191018527 Change of Packaging Materials

Bulletin Issue Date: 10/18/2019

Description of Change

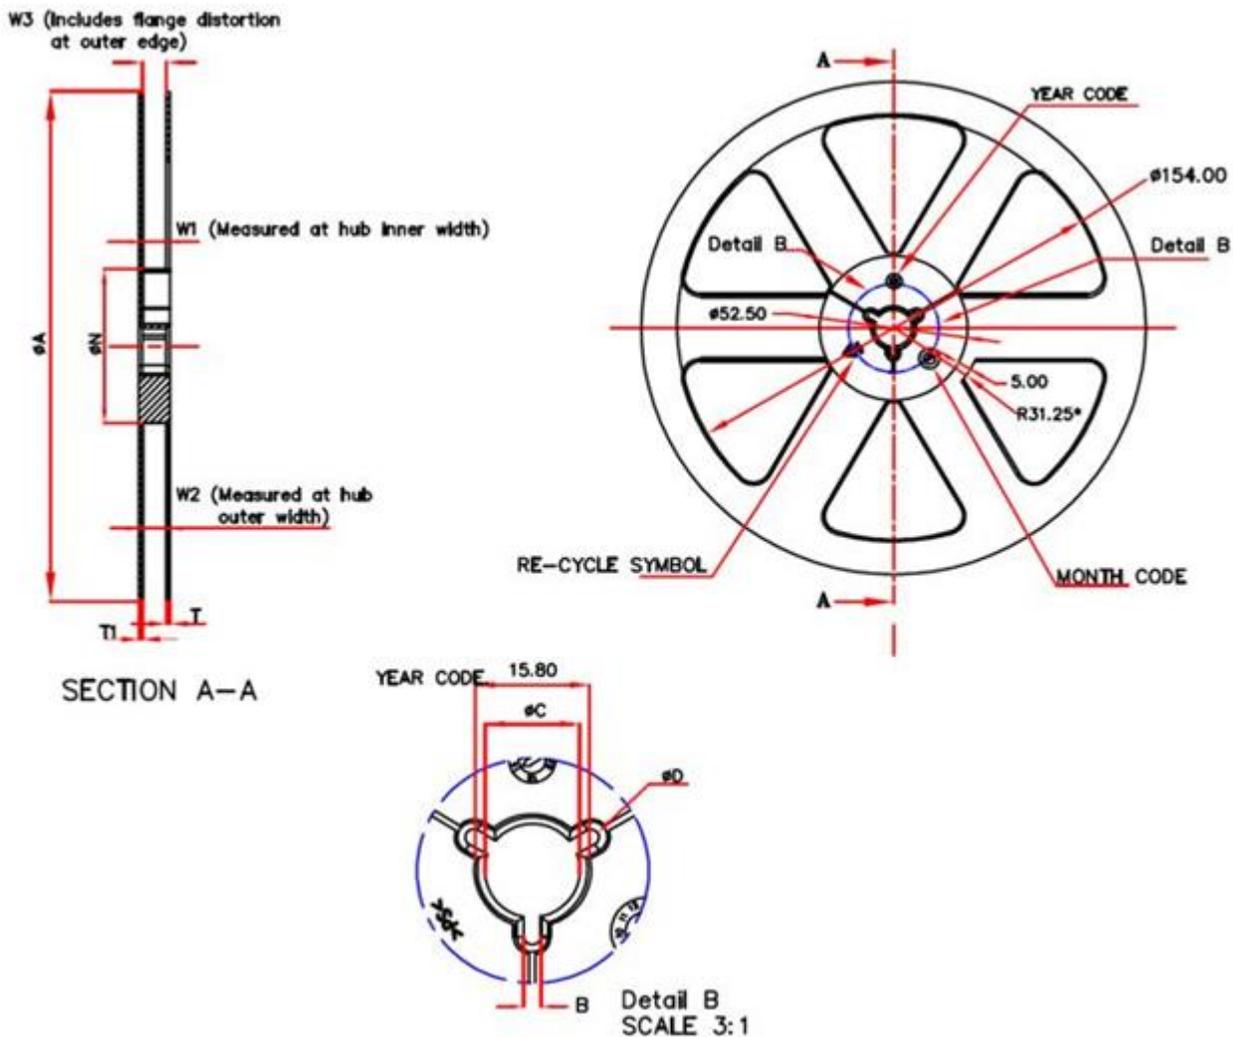
Reel - Change from ITW supplier to CPAK supplier due to End of Life (EOL) notice from ITW.

Please see Appendix area for CPAK reel drawing and comparison of ITW vs CPAK reel dimensions.

Existing Antistatic plastic reel	New Antistatic plastic reel
Dimension	26020230 (ITW)	26029017 (CPAK)
Reel Diameter (ØA)	178 mm. +/-0.5	180 mm. +0/-3.0
Overall hub diameter (ØN)	54.5 mm. +/-0.5	55 mm. +5.0/-0
Drive hole center (ØC)	13 mm. +/-0.2	13 mm. +0.5/-0.2
Splint Slot (B)	1.9 mm. +/-0.3	1.6 mm.min
Hub width (W1)	12.4 mm. +2.0/-0	12.4 mm. +2.0/-0
Hub width (W2)	18.4 mm.	18.4 mm.
Hub width (W3)	12.4 mm. +3.0/-0.05	12.4 mm. +3.0/-0.05
Thickness T1	0.85 mm. min	1.1 mm. +/-0.1
Thickness T2	0.85 mm. min	1.0 mm. +/-0.1
Surface Resistivity	1.0X10 ⁴ - 1.0x10 ¹¹ ohm/sq	1.0X10 ⁴ - 1.0x10 ¹¹ ohm/sq
Material	Polystyrene	Polystyrene
Color	Blue	Black
